SERVICE BULLETIN

M-1028

SUPPLEMENTARY SERVICE BULLETIN FILE WITH SERVICE BULLETIN M-1026 (SAFETY RECALL CODE 079)

Supplementary Service Bulletin M-1028 contains revised and additional information regarding Service Bulletin M-1026 (Safety Recall Code 079).

Figure 1. Convertible Windshield Mounting Bracket Clamps - Old Style (from Kit 91849-85A) and New Style (from Kit 91849-85B)

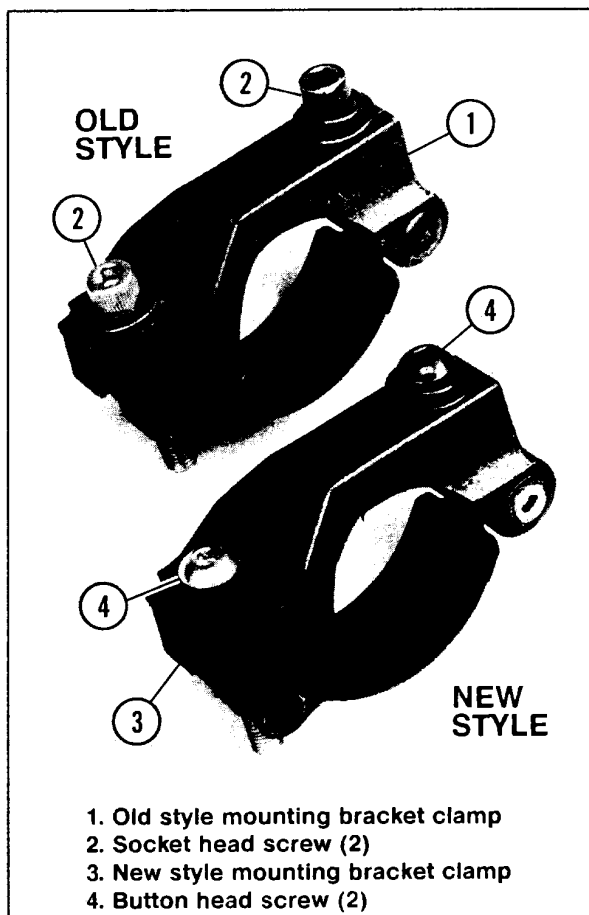
See Figure 1. FXR and FXD models equipped with accessory Convertible Windshield Kit 91849-85A will have the old style windshield mounting bracket clamps (1) installed and will require replacement of the clamps; refer below.

FXR and FXD models equipped with accessory Convertible Windshield Kit 91849-85B (shipped to dealers since April 1992) will have the new style windshield mounting bracket clamps (3) installed and will not require replacement of the clamps. However, these models may still require installation of the new button head TORX front fork pinch screws, as specified in Service Bulletin M-1026 (Safety Recall Code 079).

In order to distinguish between old style mounting bracket clamps (1) of Kit 91849-85A and new style mounting bracket clamps (3) of Kit 91849-85B, note the type of screws used in each style of clamp -- socket head screws (2) are used in old style clamps (1) of Kit 91849-85A; button head screws (4) are used in new style clamps (3) of Kit 91849-85B.

1987 - Early 1992 FXR and FXD models were originally equipped with hex socket head pinch screws on the front fork brackets. Replace the original equipment front fork bracket pinch screws and the accessory windshield mounting bracket clamps on 1987 - Early 1992 FXR and FXD models equipped with accessory Convertible Windshield Kit 91849-85A. Install Hardware Kit 93668 according to the procedure stated in Service Bulletin M-1026 (Safety Recall Code 079).

Late 1992 - Early 1993 FXR and FXD models were originally equipped with the new button head TORX pinch screws on the front fork brackets. Verify that the front fork bracket pinch screws on your particular vehicle are of the new button head TORX style; you will not need to replace these pinch screws. Replace only the windshield mounting bracket clamps on Late 1992 - Early 1993 FXR and FXD models equipped with accessory Convertible Windshield Kit 91849-85A. Install the windshield mounting bracket clamps from Hardware Kit 93668 according to the procedure stated in Service Bulletin M-1026 (Safety Recall Code 079).

Figure 2. Accessory Compact Windshield Kit 58006-87 -- Right Side Mounting Hardware

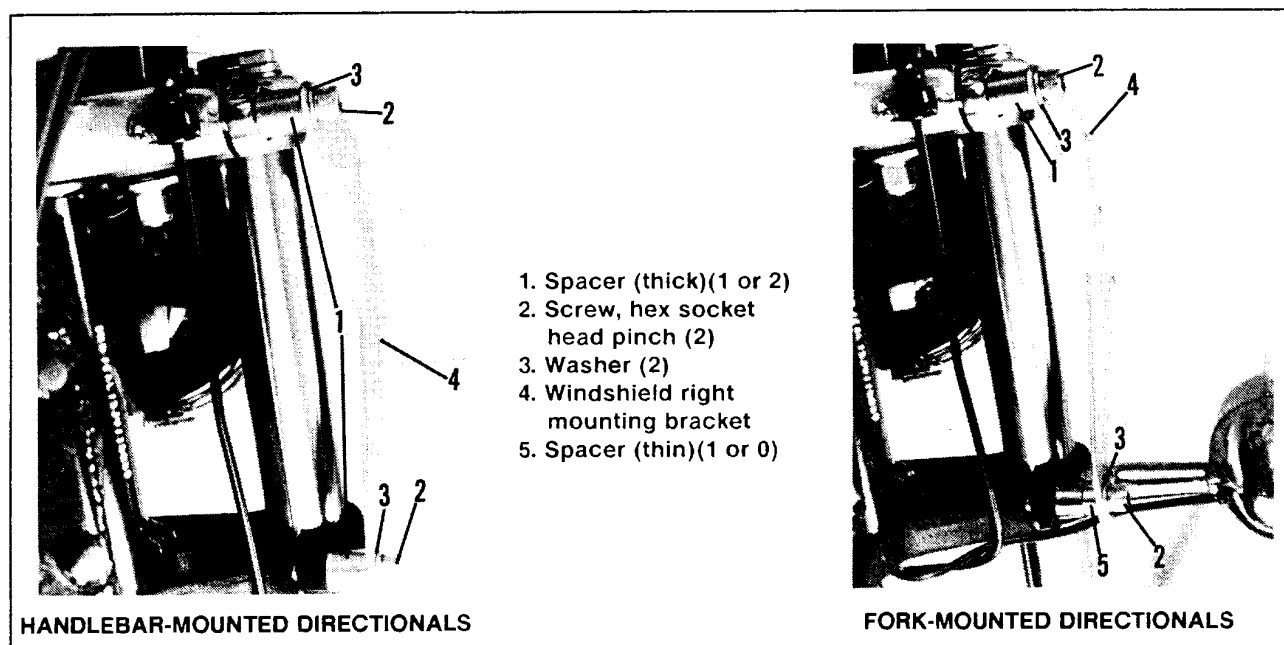
See Figure 2. 1987 - Early 1993 FXR models equipped with accessory Compact Windshield Kit 58006-87 will have hex socket head front fork bracket pinch screws (2) and old style windshield mounting brackets (4) installed. Replace the pinch screws and windshield mounting brackets on these models. Install Hardware Kit 93679, which contains the following components:

1. Support motorcycle on a center stand such that front wheel is raised slightly off the ground.
2. See Figure 2. Remove and discard fasteners which attach right side of windshield assembly to windshield right mounting bracket (4).
3. Remove hex socket head pinch screw (2), washer (3), and spacer (1) from right side of front fork upper bracket; discard screw, washer, and spacer.

4. Loosen hex socket head pinch screw (2) on right side of front fork lower bracket only enough to allow you to pivot the windshield right mounting bracket (4) forward somewhat. Pivot the mounting bracket (4) forward to expose open pinch screw hole in right side of front fork upper bracket.

5. Install new 1-1/2 in. long button head TORX screw from kit into pinch screw hole in right side of front fork upper bracket. Verify that proper right front fork tube extension exists above front fork upper bracket (must be identical to left front fork tube extension). Tighten new pinch screw to 30 - 35 ft-lbs torque.

6. Remove hex socket head pinch screw (2), washer (3), windshield right mounting bracket (4), and spacer (1 or 5) from front fork lower bracket; discard screw, washer, mounting bracket, and spacer. On models with fork-mounted directionals, lift right directional lamp assembly away from front fork lower bracket; let directional lamp hang by its wiring.

Figure 3. New Compact Windshield Mounting Hardware -- Right Side

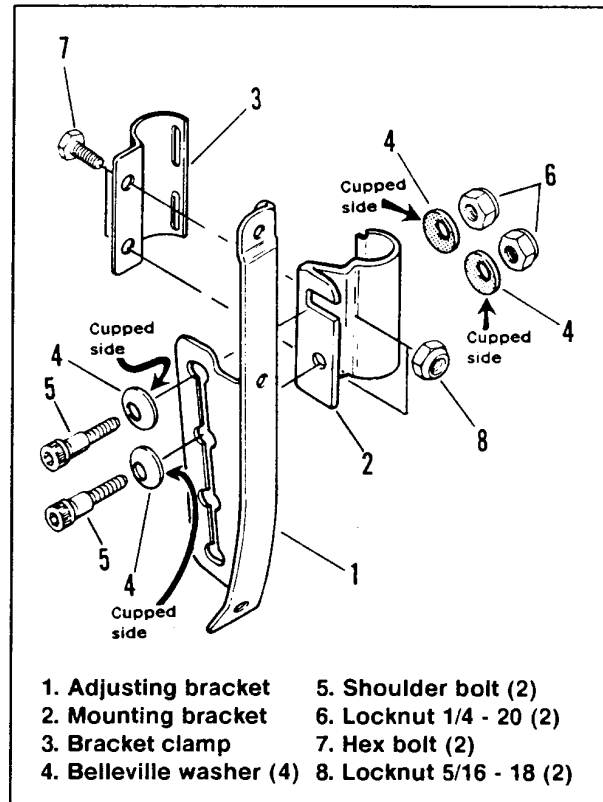
8. See Figure 3. Loosely install new windshield right mounting bracket (2) and a windshield mounting bracket clamp (3) from kit onto right front fork tube using two 5/16 - 18 x 5/8 in. hex flange bolts (7) and two 5/16 - 18 locknuts (8) from kit.

9. Position original windshield right adjusting bracket (1) (part of windshield assembly) over outboard side of new windshield right mounting bracket (2).

Do not substitute any ordinary fasteners in place of the special shoulder bolts (5) and Belleville washers (4) included with this special kit. These bolts and washers are designed to maintain a specific clamping force in this windshield mounting application.

10. Insert a shoulder bolt (5) through one Belleville washer (4) (with concave [cupped] side of washer facing away from bolt head), through slot of adjusting bracket (1), and slotted, upper hole in mounting bracket (2). Install another Belleville washer (4) (with concave [cupped] side of washer facing windshield right mounting bracket) and a locknut (6) over end of bolt. Do not final tighten at this time.
11. Install the same fastener arrangement (as in the previous step) through slot of adjusting bracket (1) and round, lower hole of mounting bracket (2). Do not final tighten at this time.

12. Verify that windshield is properly positioned (and not distorted) on motorcycle. Secure mounting bracket (2) and clamp (3) to front fork tube by tightening locknuts (8) to 12 ft-lbs torque.

Before tightening shoulder bolts (5) and locknuts (6), verify that the outer Belleville washer (4), the adjusting bracket (1), the mounting bracket (2), and the inner Belleville washer (4) are positioned over the unthreaded, larger O.D. shaft section of each shoulder bolt (5); also verify that the mating surface (shoulder) of each shoulder bolt (5) contacts the mating surface of the attached locknut (6).

13. Secure adjusting bracket (1) to mounting bracket (2) by tightening shoulder bolts (5) and locknuts (6) to 8 - 10 ft-lbs torque.
14. Repeat all the above steps for left side of vehicle.
